[2006 Chevrolet HHR](#) | [HHR \(VIN A\) Service Manual](#) | Document ID: 2479235

#06-07-30-004G: Various Concerns with Shifter and/or Ignition Key (Perform Repair as Outlined) - (May 27, 2010)

Models: 2005-2010 Chevrolet Cobalt
2006-2010 Chevrolet HHR
2005-2006 Pontiac Pursuit (Canada Only)
2007-2010 Pontiac G5
with Automatic Transmission 4T45-E (RPO MN5)

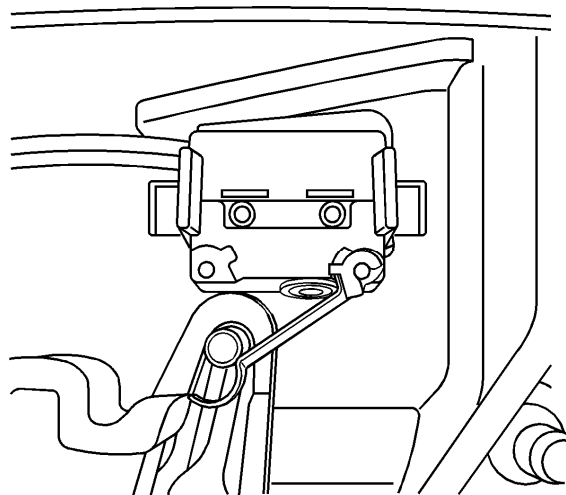
The cause of this condition may be the shifter button sticking in the handle.

Verify that the shifter button is inoperative by evaluating if the park pawl pin on the shifter assembly moves when activating the button. If the parking pawl does not move when the button is activated, the shifter handle will have to be replaced. Refer to Floor Shifter Control Knob Replacement in SI.

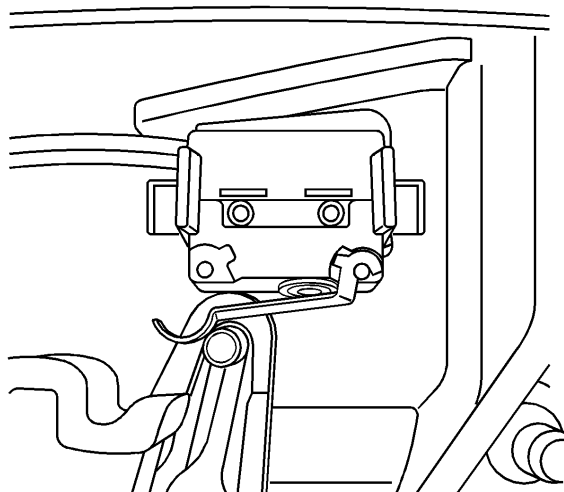
The pin that activates the micro-switch may have moved out of position (refer to illustration above). This causes the micro-switch to fail to engage when the vehicle is placed in Park. If this condition is present, the customer will not be able to remove the key from the ignition.

The illustration above shows the switch in a correct position.

Important: A change has been made to the shifter assembly for service. The replacement shifter assembly will read PRNDIL (Park, Reverse, Neutral, Drive, Intermediate and Low).

Verify that the micro switch is out of position. Replace the shifter assembly. Refer to Transmission Control Replacement in SI.
